REMARKS/ARGUMENTS

Appl. No.: 09/975,168
Amdt. dated 12/08/2004
Reply to Official Action of September 8, 2004

Amendments to the Drawings:

FIG. 1

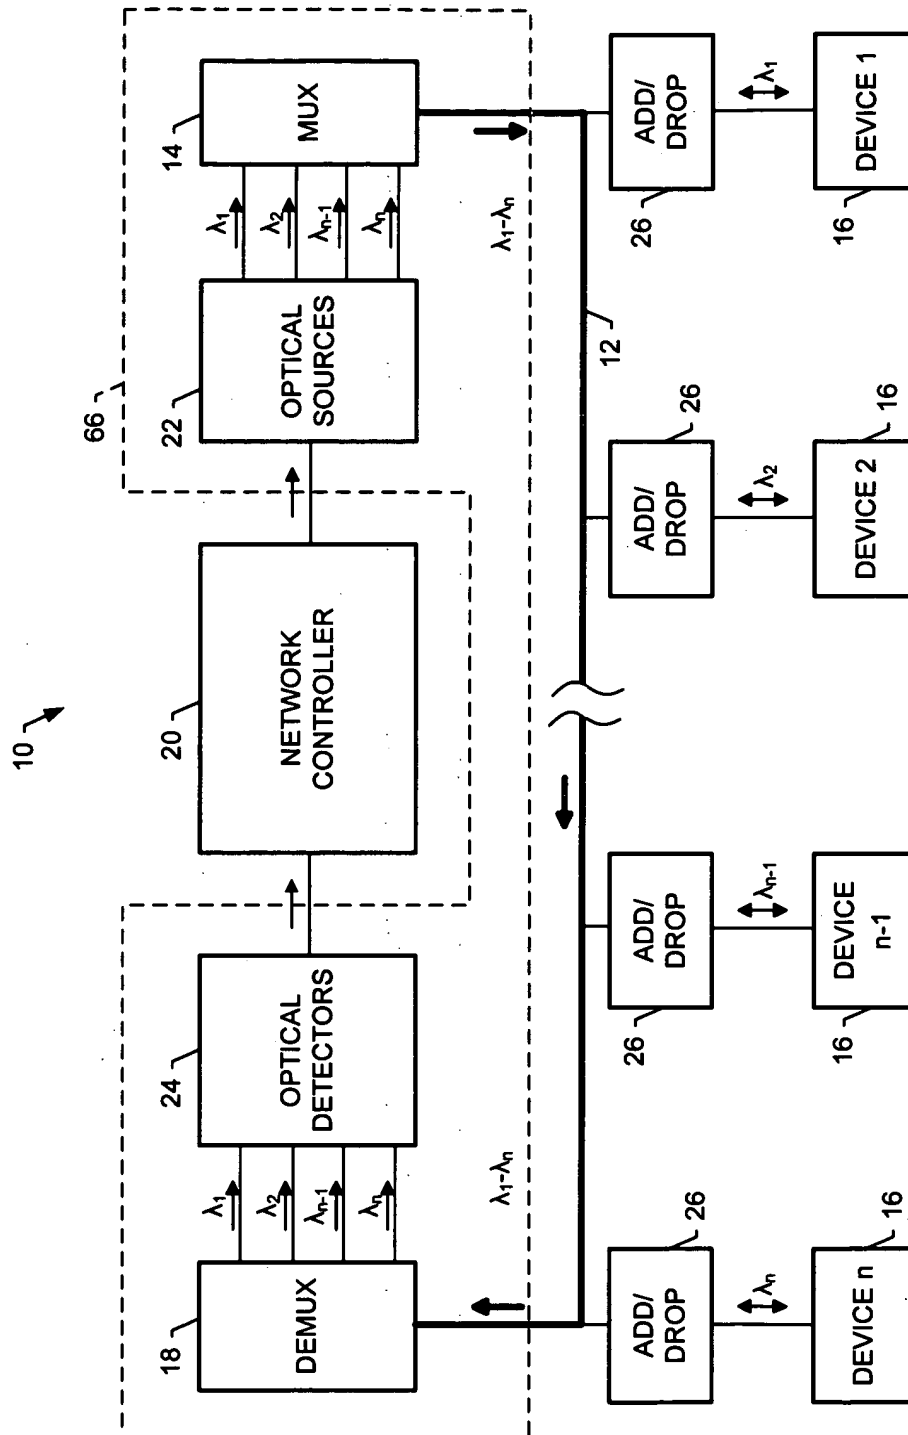
Applicants appreciate the thorough examination of the present application, as evidenced by the first Official Action. The Official Action objects to the drawings under 37 C.F.R. 1.83(a) for failing to show every feature of the invention. More particularly, the Official Action alleged that the drawings fail to show the transceiver, as recited in Claims 7-11. The Official Action also rejects Claims 1-20 under 35 U.S.C. § 103(a) as being unpatentable over U.S. Patent No. 5,717,795 to Sharma et al. In addition, the Official Action rejects Claims 21-26 under 35 U.S.C. § 103(a) as being unpatentable over the Sharma patent, in view of U.S. Patent No. 4,089,584 to Polczynski.

In response to the Official Action, Applicants have amended FIG. 1 to include transceiver 66. Accordingly, Applicants have also amended the specification of the present application to include the callout for the transceiver. Applicants note that as the transceiver added to FIG. 1 merely illustrates a combination of the elements (e.g., multiplexer 14, demultiplexer 18, optical sources 22, optical detectors 24) disclosed in the specification of the present application, no new matter has been added to the present application by virtue of the amendment to FIG. 1 or the accompanying amendment to the specification. Thus, Applicants respectfully submit that the objection to the drawings is overcome.

The enclosed sheets of formal drawings, which include FIGS. 1-3, replaces the original sheets including FIGS. 1-3. In view of the Official Action's objection to the drawings under 37 C.F.R. 1.83(a) as not showing every feature of the invention specified in the claims, in the attached replacement drawing sheet including FIG. 1, previously omitted transceiver 64 has been added. An annotated drawing sheet including FIG. 1 is also enclosed to illustrate the added transceiver.
